STATE OF CONNECTICUT  
CONNECTICUT SITING COUNCIL

DOCKET NO. 499

HOMELAND TOWERS, LLC AND NEW CINGULAR WIRELESS PCS, LLC d/b/a AT&T  
RESPONSES TO INTERVENOR GREENBAUM INTERROGATORIES

CT1341  
 16 Coote Hill Road  
 Sherman, CT 06784  
 41.5335722 N  
 -73.4925306 W  
 Antenna Ht: 166' AGL  
 GE: 903' AMSL

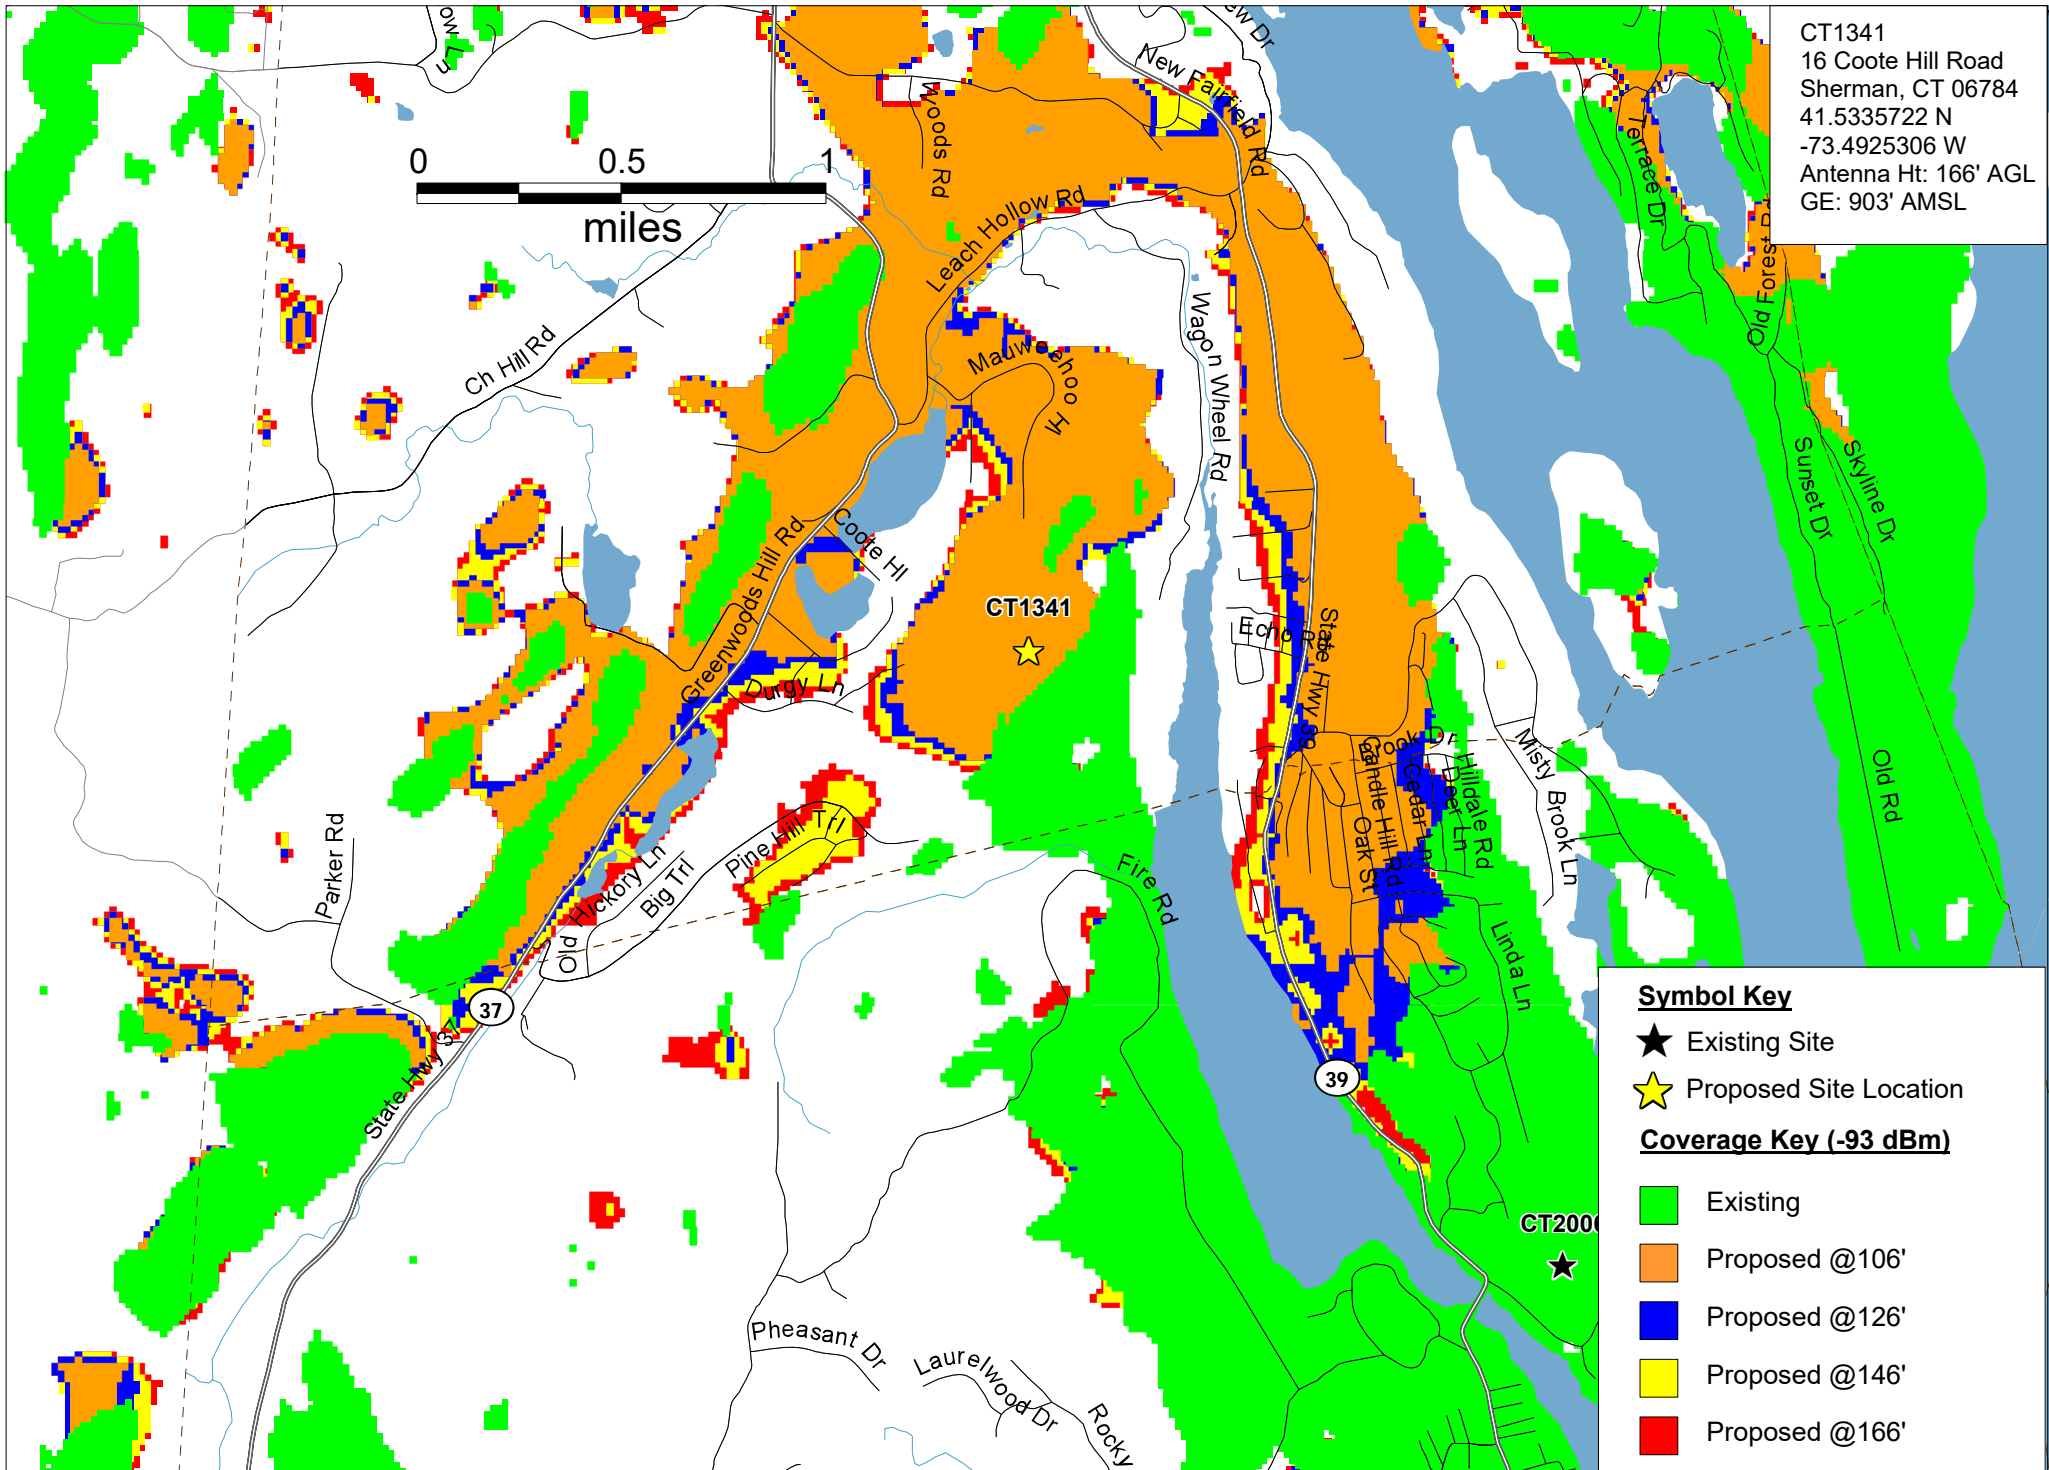
- A50. *The height of the Proposed Facility is the minimum height needed to provide service.*
- Q51. The Intervenor demands that the Applicant provide propagation data for 120', 130' and 150', the maximum height referred to in the Sherman Planning and Zoning regulations referred to above.

- A51. *Coverage plots for antenna heights of 170, 150, 130 and 110 feet AGL are included herein as Attachment 1 and sufficient for purposes of evaluating coverage including the contours between 110 and 130 feet AGL.*

- A67. *There are several heights analyzed in coverage plots included in Attachment 1 herein, including 110' AGL, which demonstrate the need for the tower height as proposed. See response #51 above. Additional coverage plots from the Applicants at these low heights will not specifically aid the Council further in its deliberations. The Applicants respectfully submit that the Intervenor may choose to submit evidence in this regard if it so chooses.*

# **ATTACHMENT 2**

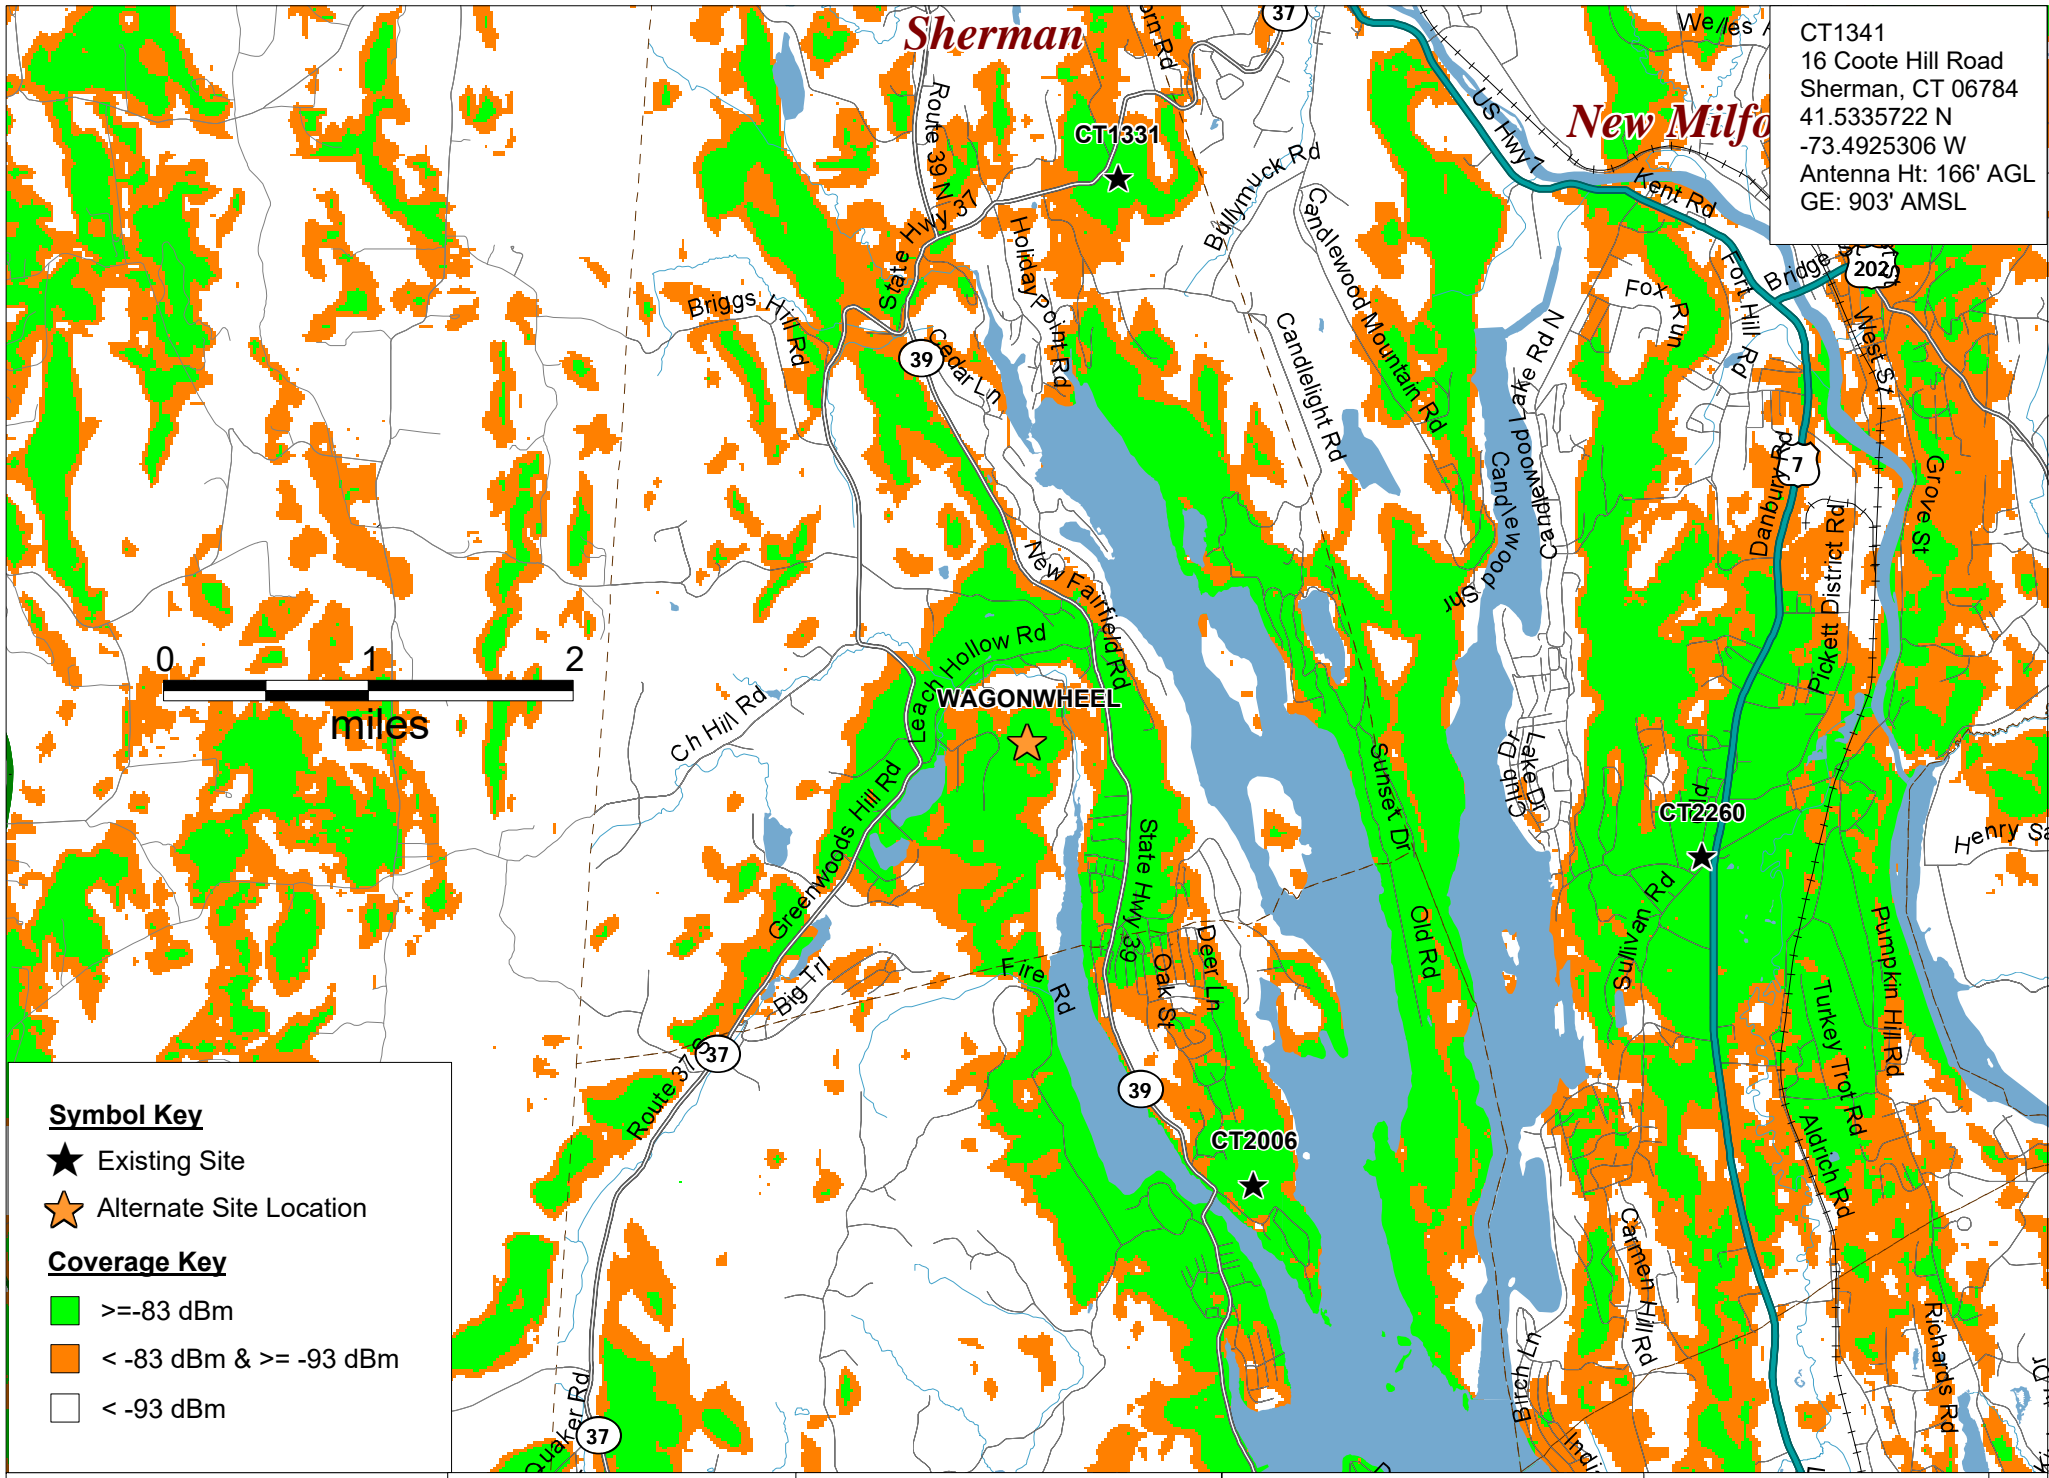
- Q62. The Intervenor further demands that the Applicant provide the RF engineer's data that ruled these out as suitable sites, in contradiction to the findings of RCC Communications

- A62. *Please see the coverage plot for the Wagon Wheel property included herein as Attachment 2.*
- Q63. The Intervenor demands that the Applicant provide RF data for tower heights that would accommodate three additional carriers and what their effective propagation maps would look like at each of those heights.
